TECHNICAL BULLETIN

TB-25-001

Title: Revised Three Phase Underground-Fed Transformer Bank Standards No. T-3-1 and T-5

Department: Distribution Standards and Materials

**THREE PHASE UNDERGROUND-FED TRANSFORMER BANK
MAXIMUM VOLTAGE: 13.2 KV**

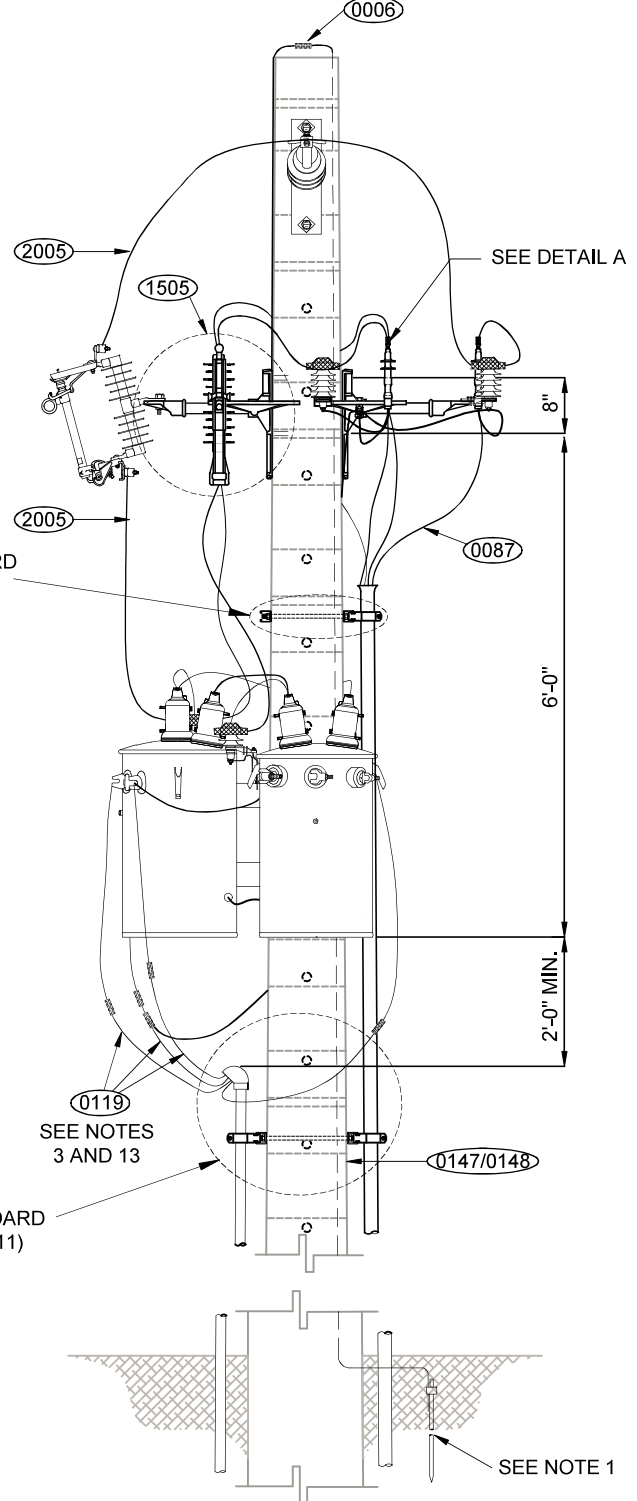
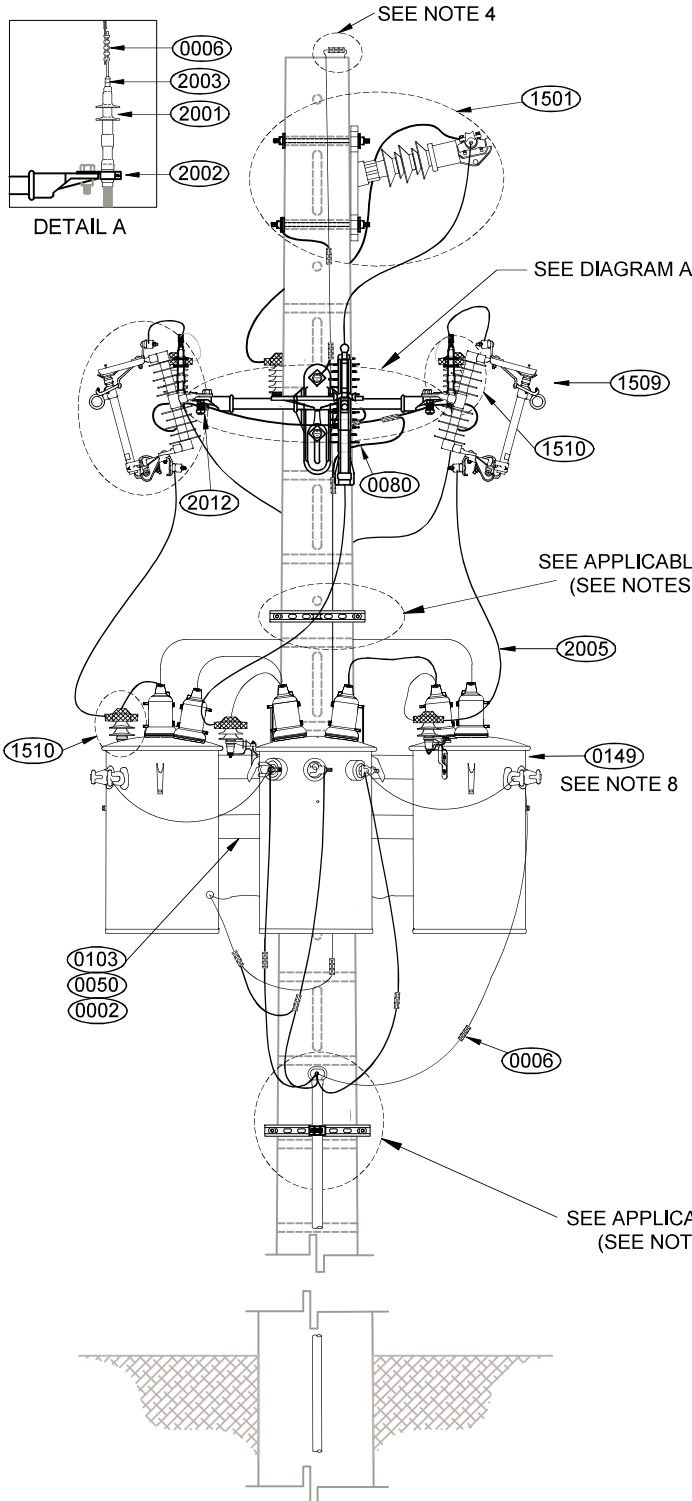
Modifications were made in order to simplify the construction, maintaining compliance with current applicable industry codes and standards. Among the most significant ones are:

- Risers' ducts installation placement on a different side of the pole in both standards.
- Notes were updated to provide clarity for field implementation and inspection.
- Materials list names were conformed with the updated Distribution System Materials List (document no. 4300.018).
